UNITED STATES PATENT AND TRADEMARK OFFICE

10/589,753

Office Action Summary	Application No. 10/589,753	Applicant(s) KOGAN-FRENK, ENRIQUE	
	Examiner Michael R. Ballinger	Art Unit 3732

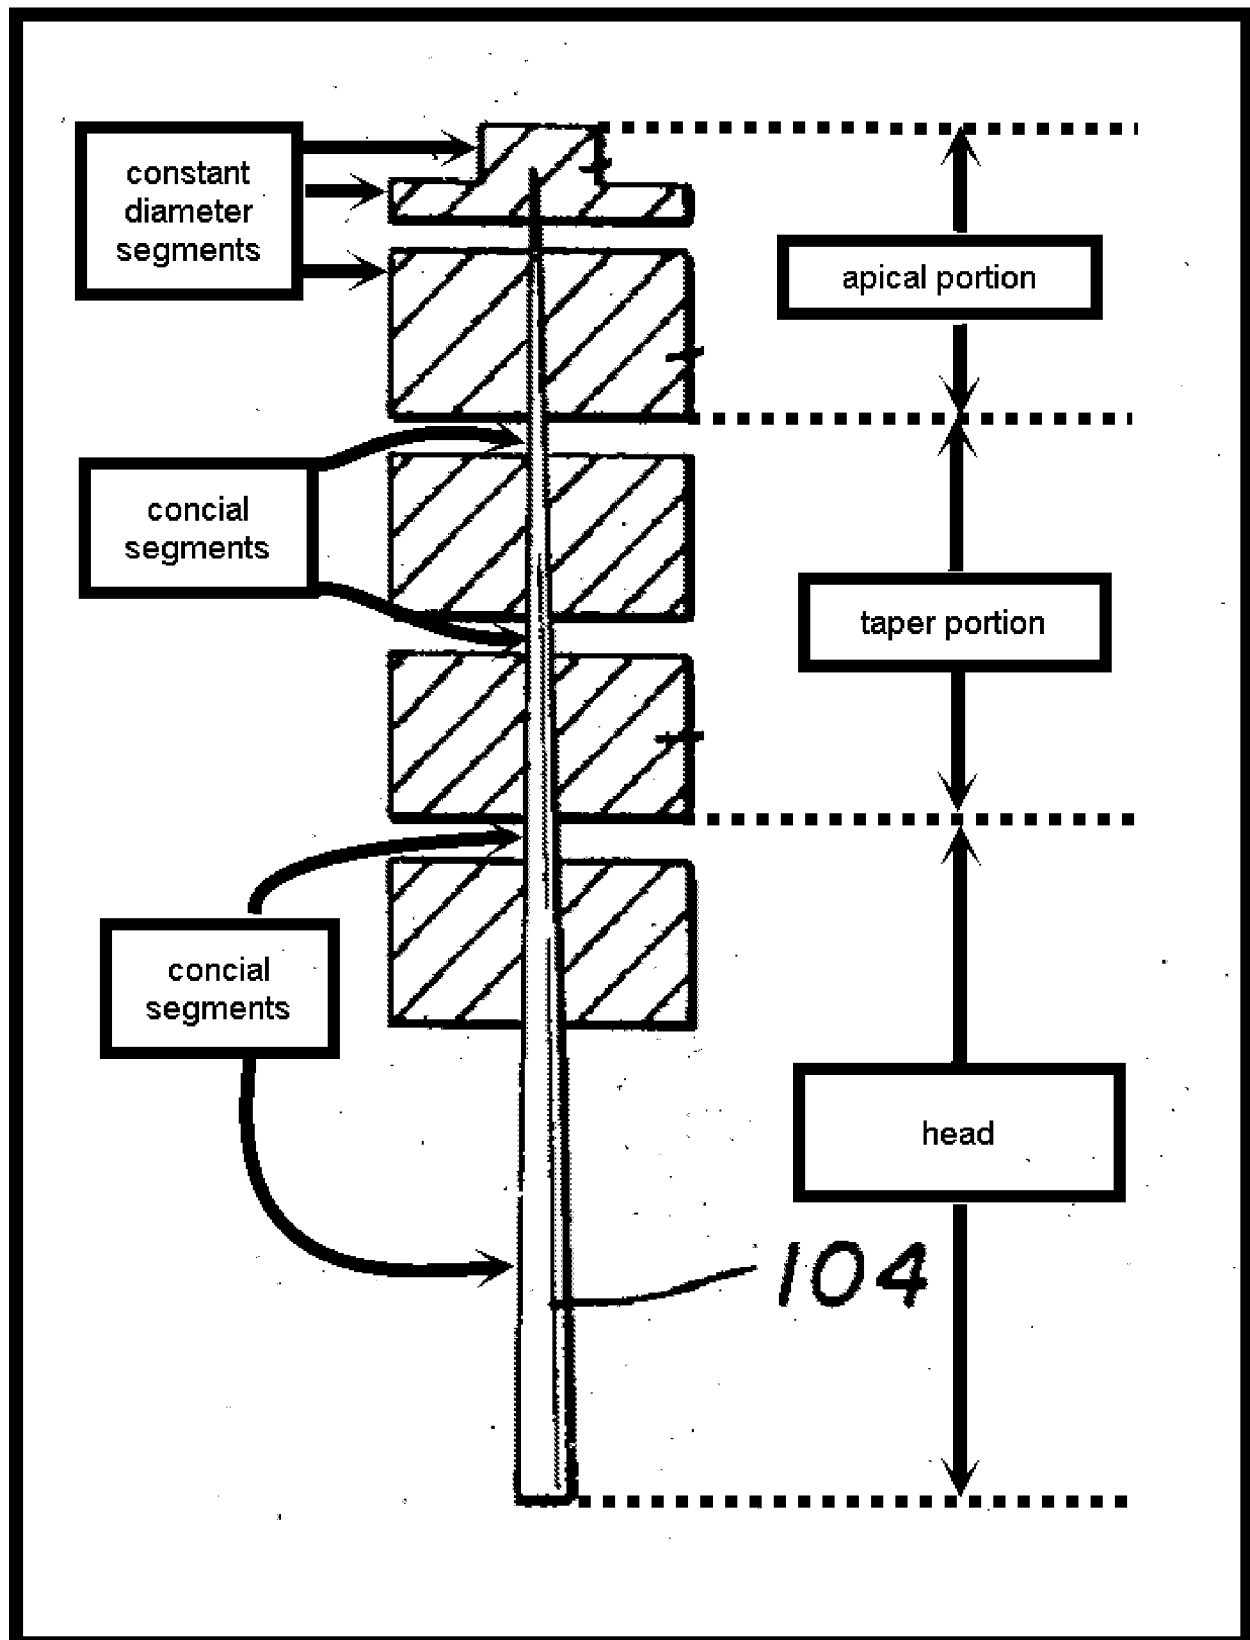
14. Claims 11 is rejected under 35 U.S.C. 102(b) as being anticipated by Malmin (U.S. 3,949,479).

15. Per claim 11, figure 14 of Malmin teaches an intra-radicular post of adjustable dimensions, for rebuilding of teeth, with treatment passages, including an apical portion (as illustrated below), formed by constant diameter segments (as illustrated below, the Examiner notes, the segments shown below are of constant diameter because each segment has a constant diameter), a tapered body (as illustrated below), formed by conical segments (i.e., the tapered portions of the metal core pin, 104 as illustrated below) and adjacent the apical portion; and a head (as illustrated below), formed by conical segments (as illustrated below), and adjacent to the tapered body.

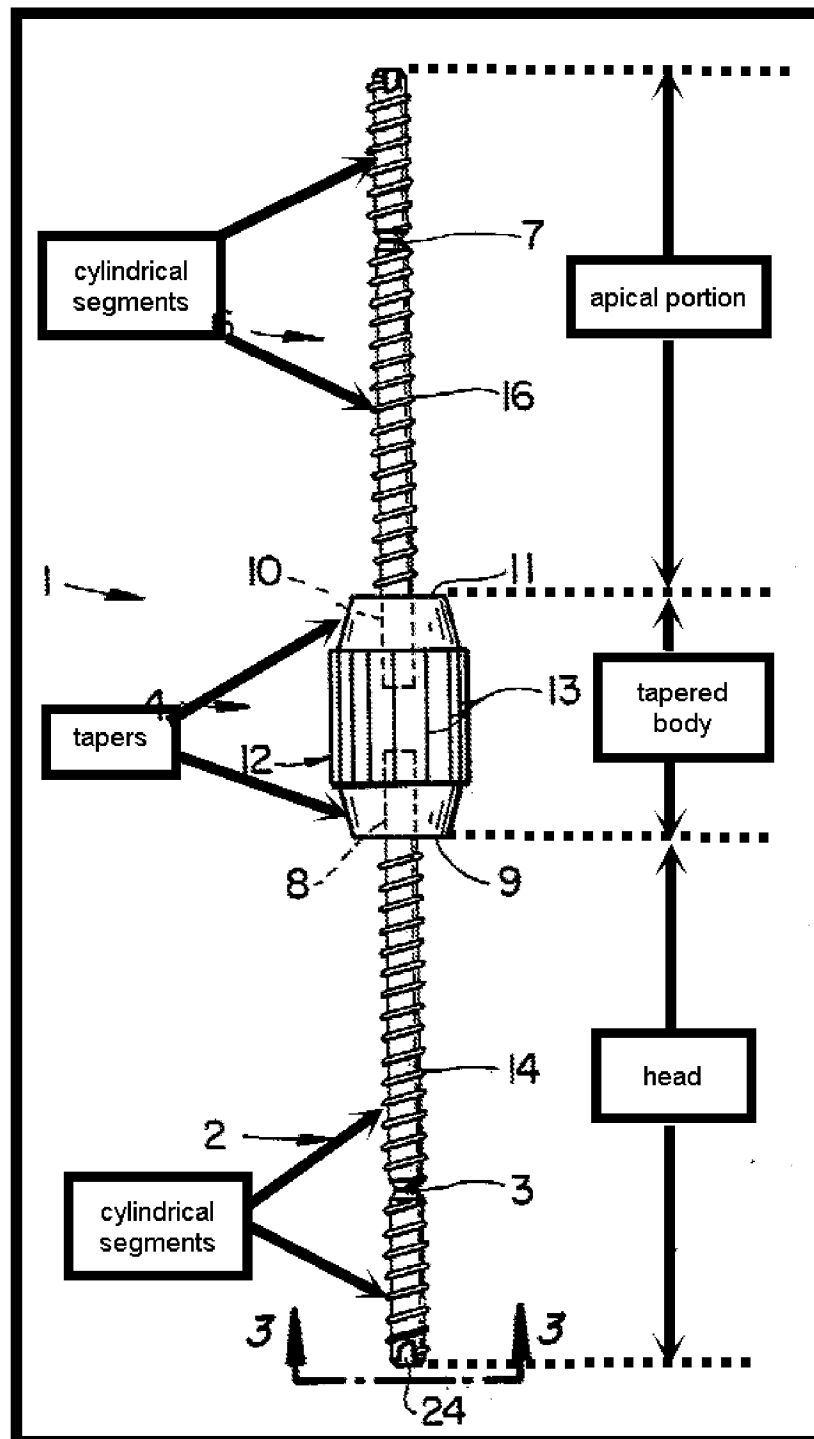
16. Claims 18-20 are rejected under 35 U.S.C. 102(b) as being anticipated by Rovins (U.S. 4,171,569).

17. Per claims 18-20 figure 1 of Rovins teaches an intra-radicular post of adjustable dimensions, for rebuilding of teeth, with treatment of the passages, including an apical portion (6) formed by a plurality of cylindrical segments (i.e., shaft 6, where the segments are delineated by the fracture groove, 7), a taper body (i.e., the handle 4 has a tapered portion at each end, as illustrated below) adjacent to the apical portion (6), a head (i.e., shaft, 2) adjacent the body, formed by a plurality of cylindrical segments (i.e., shaft 2, where the segments are delineated by the fracture groove, 3); where upon the post height can be modified by realizing a cut in the apical portion (at the fracture groove, 7) and a cut in the post head (at the fracture groove, 3). The Examiner notes that "whereupon the post height can be modified by realizing at least one of up to two cuts in the apical portion and up to three cuts in the post head" is a functional limitation. A functional limitation use of the claimed invention must result in a structural difference between the claimed invention and the prior art in order to patentably distinguish the claimed invention from the prior art. If the prior art structure is capable of performing the intended use, then it meets the claim. In the instant case, the device of Rovins is capable of being cut at least at the fracture grooves (3 and 7) and could additionally be cut anywhere along the length of the device multiple times. As such, the Examiner submits, the device of Rovins anticipates claims 18-20 as claimed.

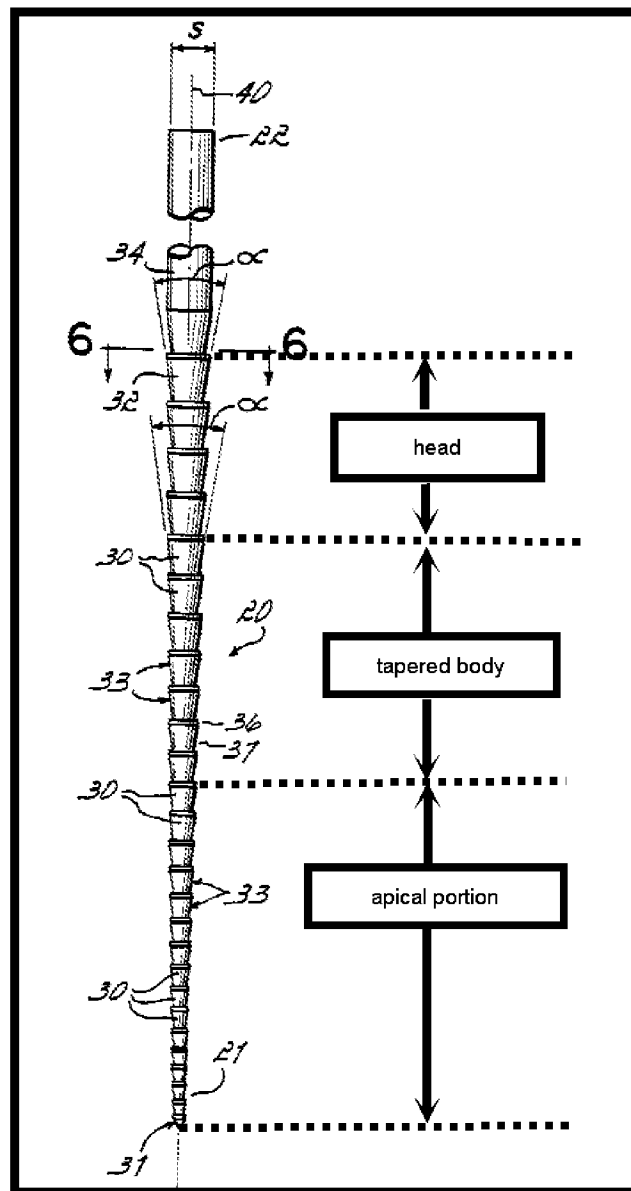
24. Per claim 15, figure 3 of Garman teaches the head comprises two lateral flat faces (i.e., legs, 69).
